# UNITED STATES DEPARTMENT OF THE INTERIOR BUREAU OF LAND MANAGEMENT

## SUNDRY NOTICES AND REPORTS ON WELLS Do not use this form for proposals to drill or to re-enter an

#### Dale H. Parke B Tract C #13 Deepening Program

#### Dale H. Parke B Tract C #13 Premier Oil & Gas Inc. 30-015-32380 May 10, 2013 Conditions of Approval

Centralizer Diagram

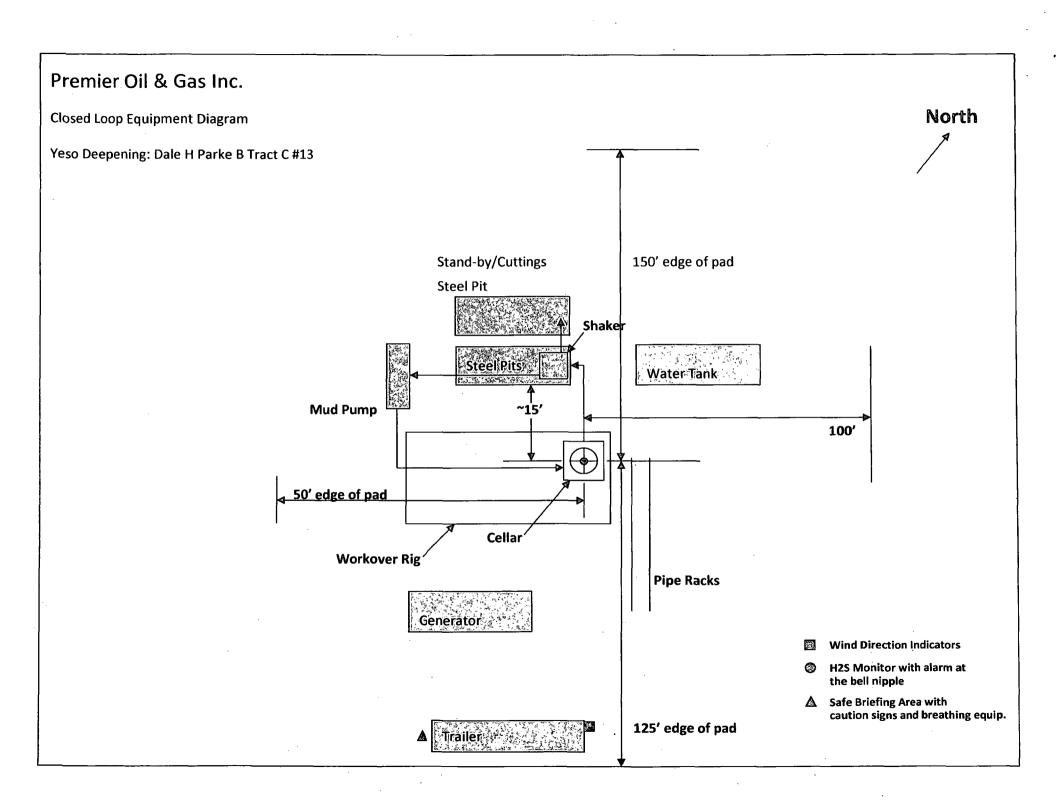
- 5. BOP to be tested to **1000 psi** based on BHP expected.
- 6. Variance for stand-off of less than 0.422" is approved due to NMOCD classifying the formations in this area as the Yeso group.
